EN 1993-4-2:2007/AC

Eurocode 3 - Design of steel structures - Part 4-2: Tanks

This corrigendum becomes effective on 29 July 2009 for incorporation in the three official language versions of the EN.

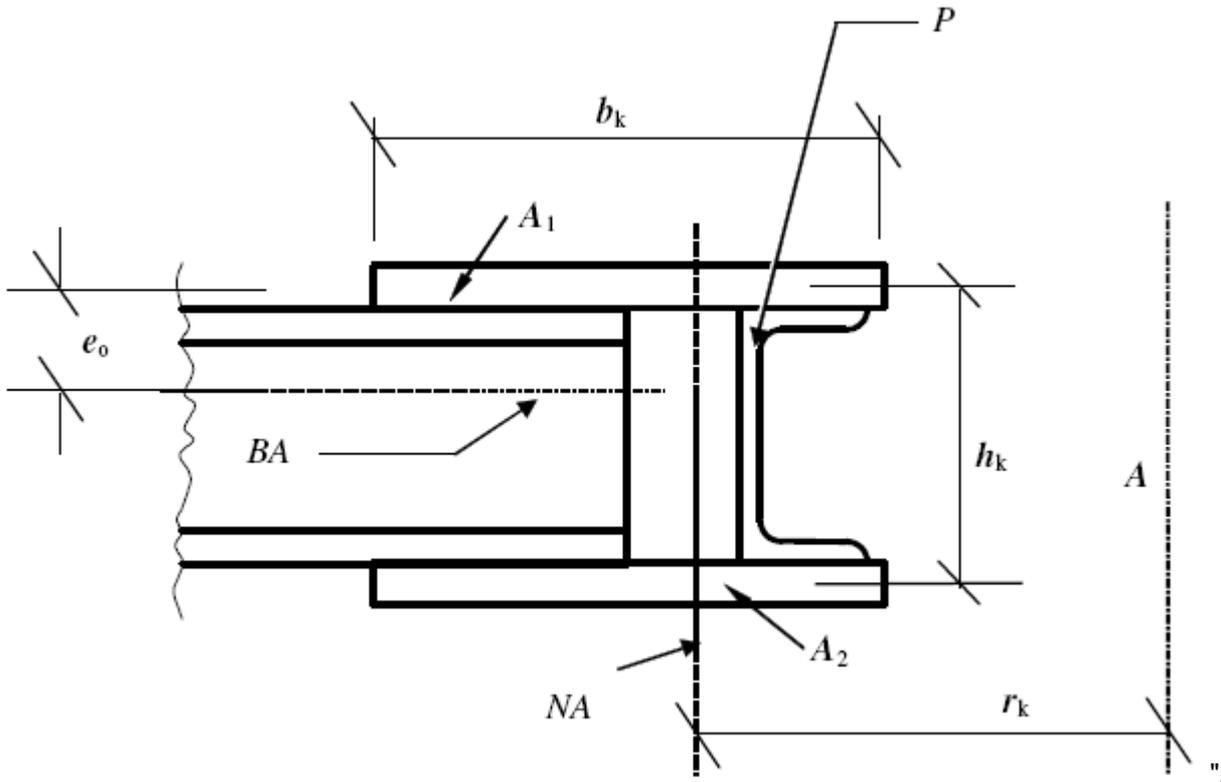
Paragraph "(10)", "Figure 11.3", replace the figure with the following one:

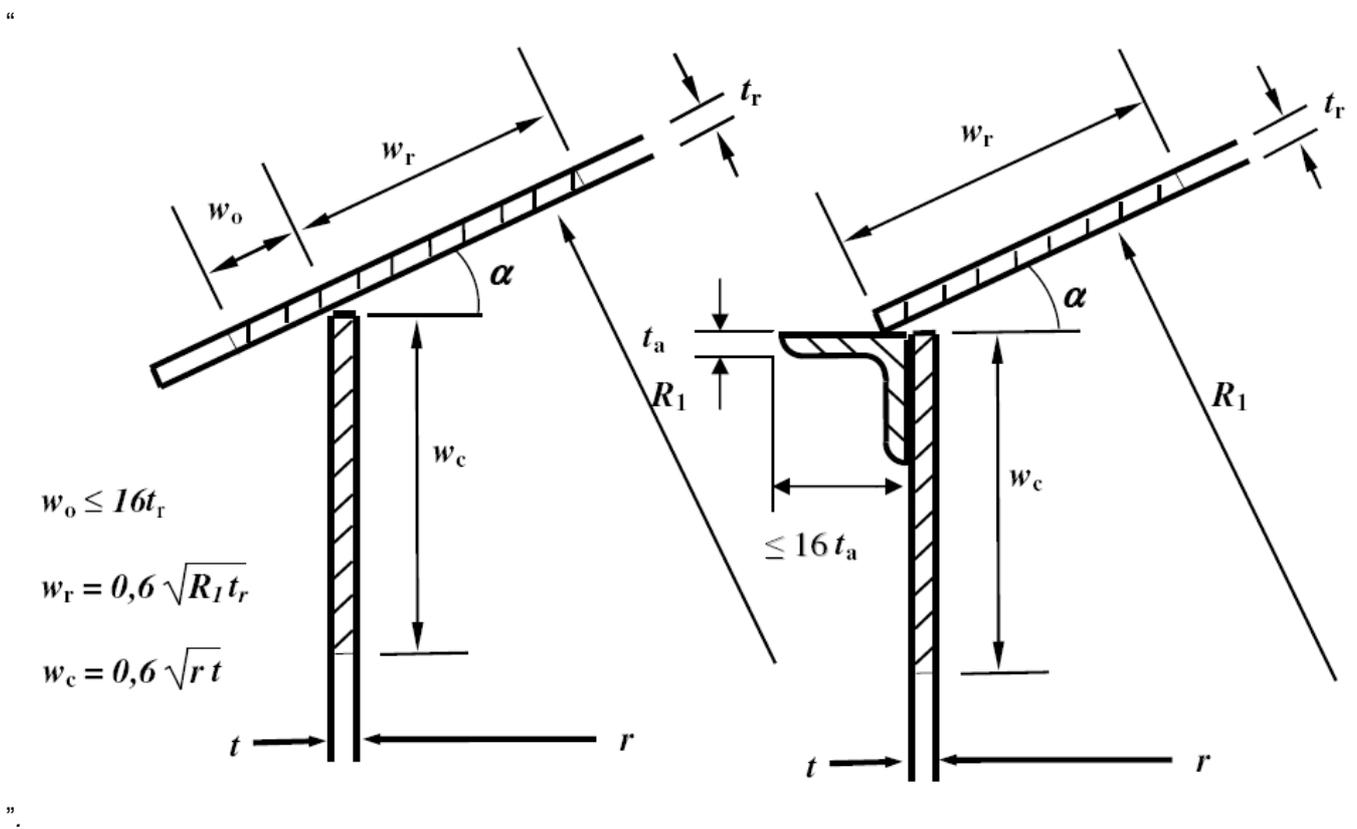
Paragraph "(5)", "Figure 11.4", replace the figure with the following one:
